ADDENDUM #2

Eugene School District 4J
Willard Site Gymnasium Remodel Asbestos Abatement Project 2020
Eugene, Oregon

DATE: January 07, 2020

Diagram A-1

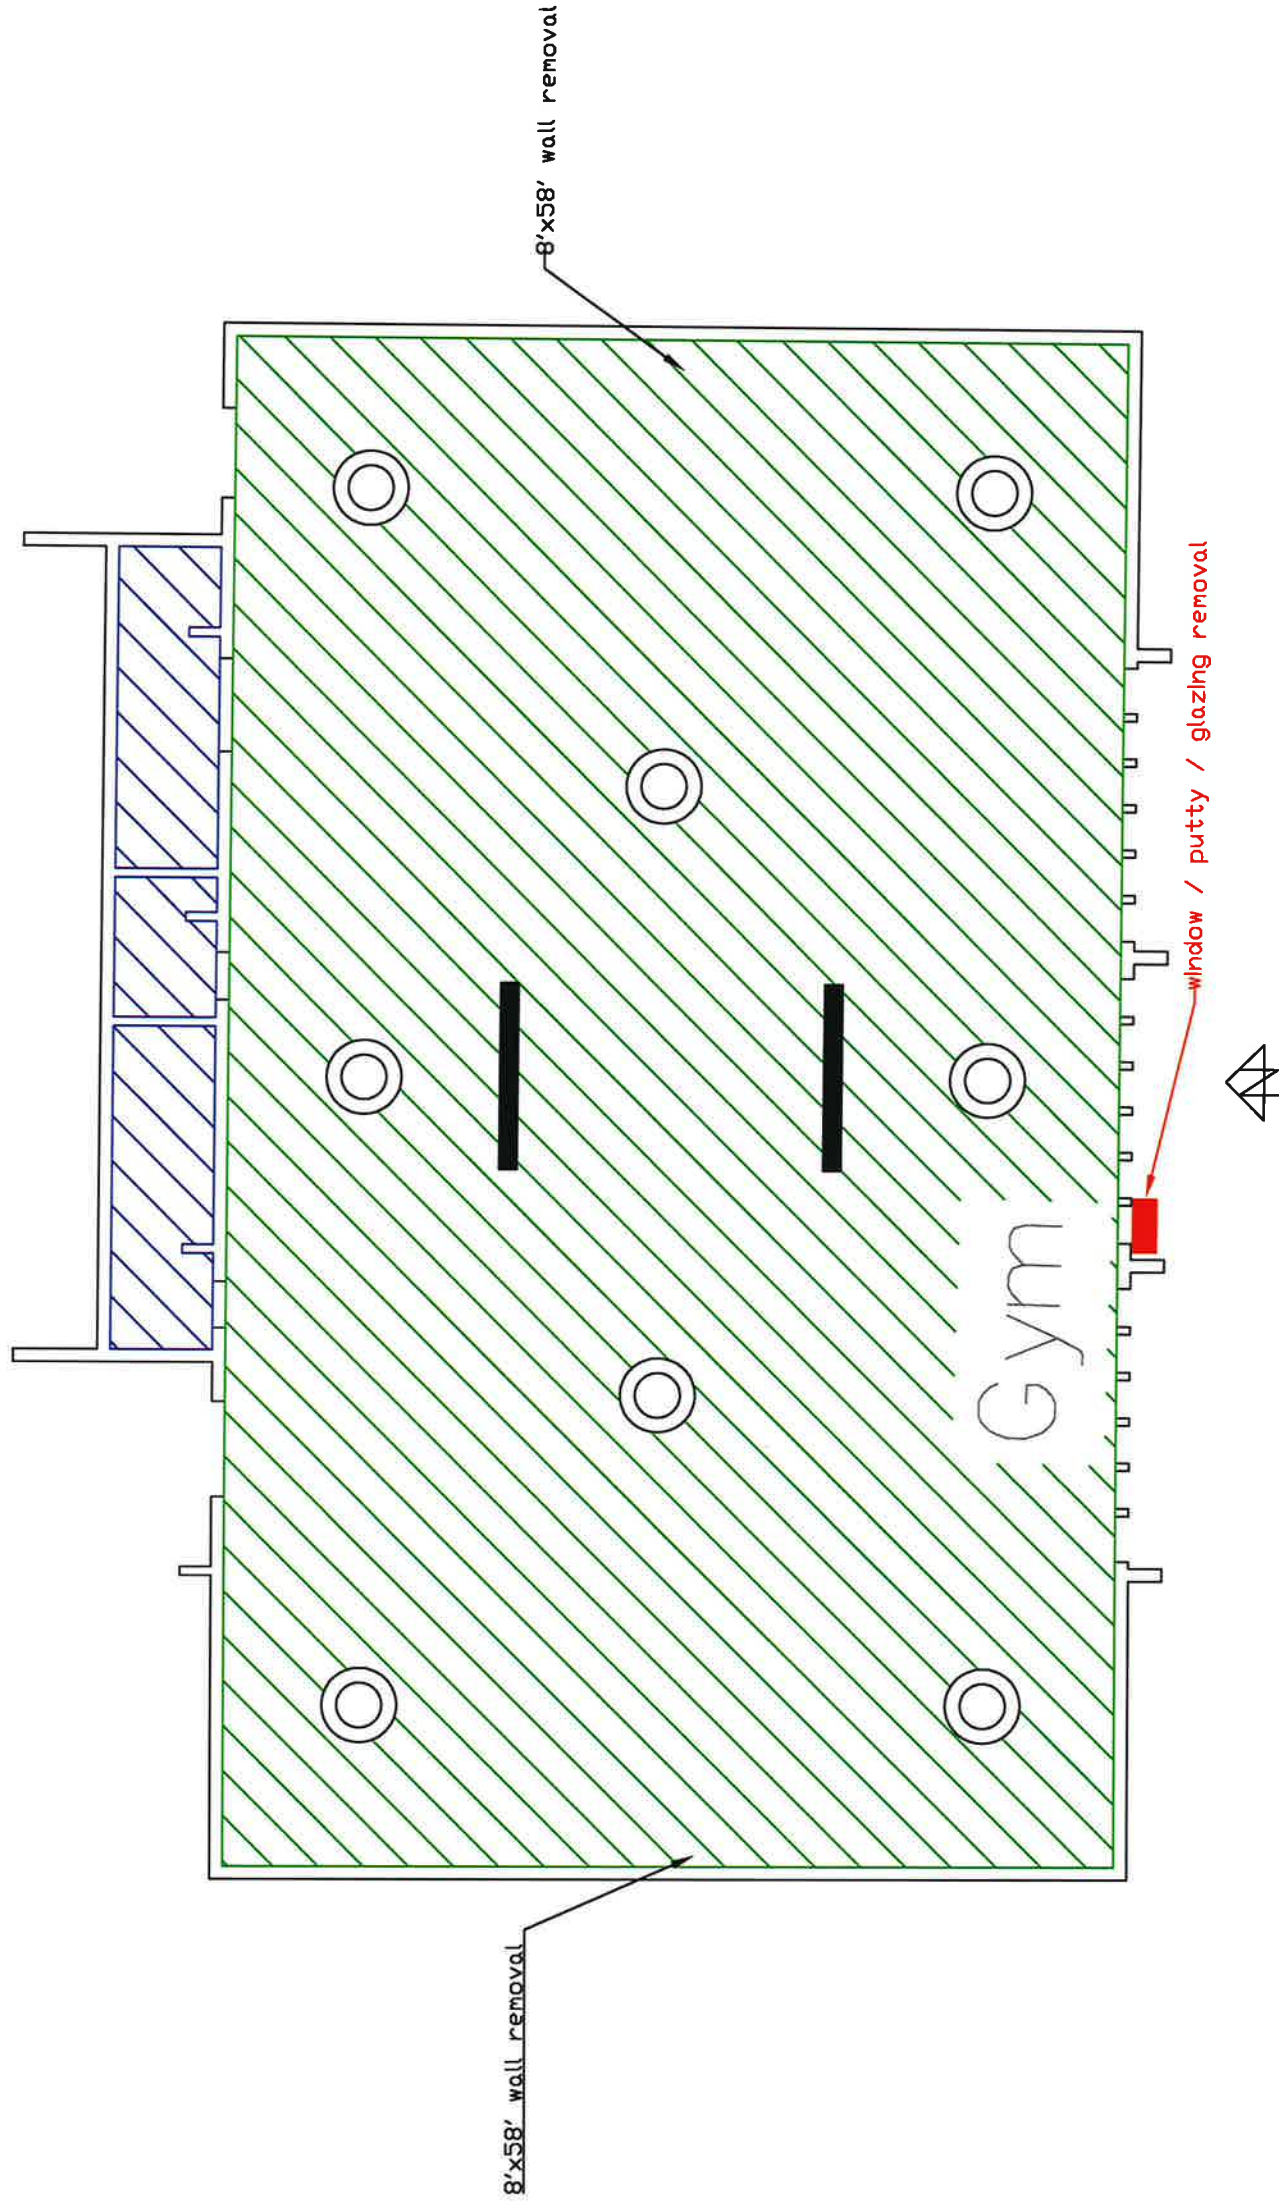
Delete 4'x58' from Drawing A-1 along the west and east walls in the Abatement Floor Plan that is provided in the Project Manual

Add 8'x58' to Drawing A-1 along the west and east walls in the Abatement Floor Plan attached to this Addendum
